#### Southern Nuclear Operating Company <u>Vogtle Early Site Permit Application</u> <u>Response to Requests for Additional Information Letter No. 6 Involving Hydrology</u>

Response to March 15, 2007 RAI Letter No. 6

RAI Figure 2.4.12-1.2 Marl Aquitard Hydrographs for the Period 1985 to 1987

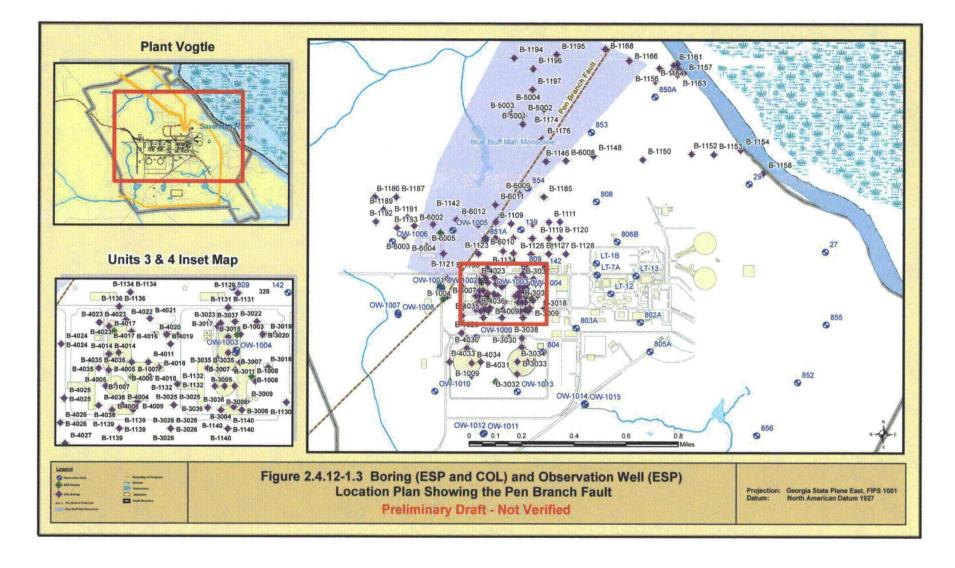
RAI Figure 2.4.12-1.2 shows groundwater level elevations in the BBM for the July 1985 to January 1987 period to range from about 104 to 127 ft msl, with a seasonal fluctuation averaging about 4.5 ft. These groundwater level elevations are similar to the groundwater levels reported for OW-1001, which range from about 114 to 118 ft msl. The average seasonal fluctuation in groundwater levels measured in OW-1001 of 4.4 ft is also of similar magnitude to the seasonal fluctuation in groundwater levels measured in the marl. While these seasonal fluctuations correlate more with the Tertiary aquifer than the Water Table aquifer, this is considered to be due to a pressure response in the marl and not a reflection of movement of groundwater into or out of the marl.

RAI Figure 2.4.12-2.3 Water Table Aquifer Hydrographs and Total Annual Precipitation for the Period 1979 - 2006

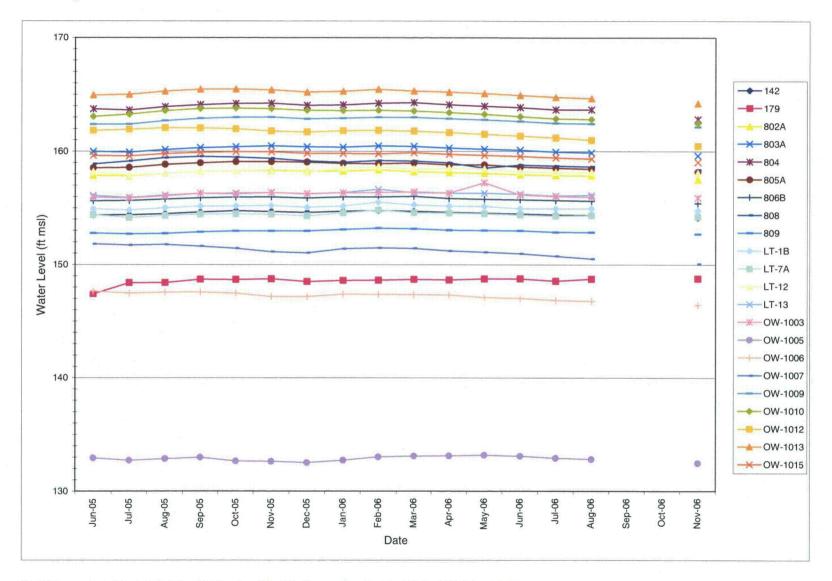
#### 2.4.12-2 (c) Discuss the reasons why the temporal variability of the water levels in the Water Table Aquifer during the period from 2005 to 2006 (Figure 2.4.12-6) were reduced substantially compared to those before 2005 (Figures 2.4.12-4&5).

RAI Figure 2.4.12-2.3 shows the groundwater level data for the Water Table aquifer available for the 1979 through 2006 period. Also shown on this figure is annual precipitation measured at three climate stations close to the VEGP site, which includes the Augusta WSO Airport, Waynesboro 2 NE, and Milen 4N climate stations. Precipitation data were obtained from the South Carolina Department of Natural Resources website, Southeast Regional Climate Center (<u>http://www.dnr.sc.gov/climate/sercc/index.html</u>). In addition, the Palmer Drought Severity Index (PDSI) and Palmer Hydrological Drought Index (PHDI) are plotted on RAI Figure 2.4.12-2.5 for the same period. The PDSI attempts to measure the duration and intensity of the long-term cumulative meteorological drought and wet conditions. The PDHI is another long-term drought index intended to measure the hydrological impacts of drought (e.g., reservoir levels, groundwater levels, etc.). PDSI and PHDI data were obtained from the National Oceanic and Atmospheric Administration website (<u>ftp://ftp.ncdc.noaa.gov/pub/data/cirs/</u>). These indices provide an indication of the severity of a wet or dry spell. The indices generally range from +6 to -6 with negative values denoting dry spells and positive values denoting wet spells. Values of +0.5 to -0.5 indicate normal conditions.

RAI Figure 2.4.12-2.3 shows that between the period 1979 to 1984, groundwater level elevations in the Water Table aquifer were impacted (lowered) by construction dewatering of the power block excavation for VEGP Units 1 and 2 that was in effect from June 1976 to March 1983. The hydrographs suggest that groundwater elevations at distances of about 1,000 ft or more from the excavation were relatively unaffected by dewatering (observation well 804) and that it took about one year for the groundwater to recover after dewatering activities were completed.

Figure 2.4.13-1 Conceptual Model for Evaluating Radionuclide Transport in Groundwater

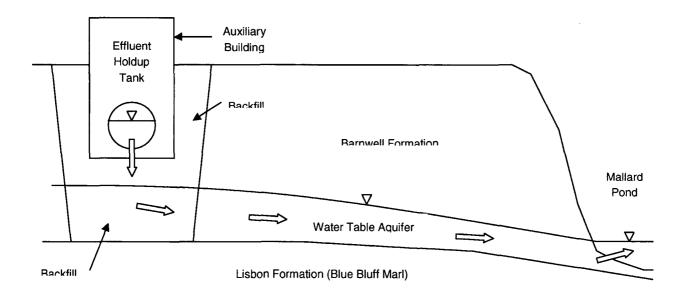
2.4.13-1 Provide and incorporate into the SSAR a discussion of the process used to establish that the conceptual model for the transport pathways and travel times presented in the SSAR represents the most conservative of the various other feasible alternative estimates by considering other pathways from the south of a proposed plant where a radwaste holding tank might be located. For example, a potential pathway might consist of travel of contaminants towards the west and then to the north towards the Mallard Pond.

Figure 2.4.13-1 illustrates the conceptual model used to evaluate an accidental liquid release of effluent to groundwater, or to surface water via the groundwater pathway. The key elements and assumptions embodied in the conceptual model are described and discussed below.
